**Regular Planning Commission Meeting
300 Wall Street, Fountain Inn, SC 29644
Monday, September 11, 2023 - 6:00 PM**

RE: Barton Hollow Final Development Plan Staff Comments, Revised – PF-2023-002

Re: Barton Hollow – Final Development Plan – PF-2023-002
Project #22212

Revised

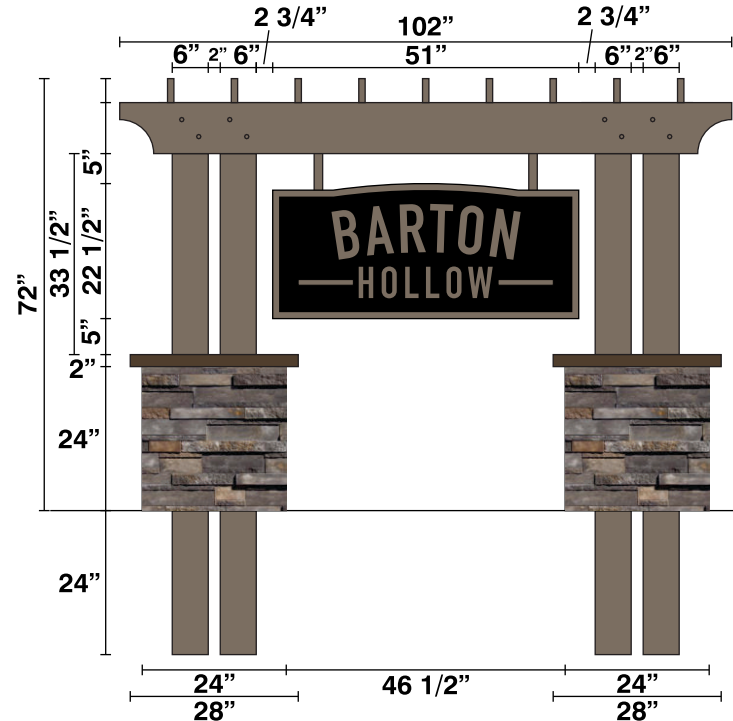
1. Per Article 6, Table 1 of the FIZO, one monument sign is permitted per street frontage. L-1 shows two signs per road frontage. Please revise.
2. Per Section 6:11 of the FIZO, "Sign shall not exceed six feet in height as measured above grade." Please revise.

1. L-1 has been revised to show a single sign along each street frontage. See attached.
2. The sign has been revised to not exceed 6'. See attached.
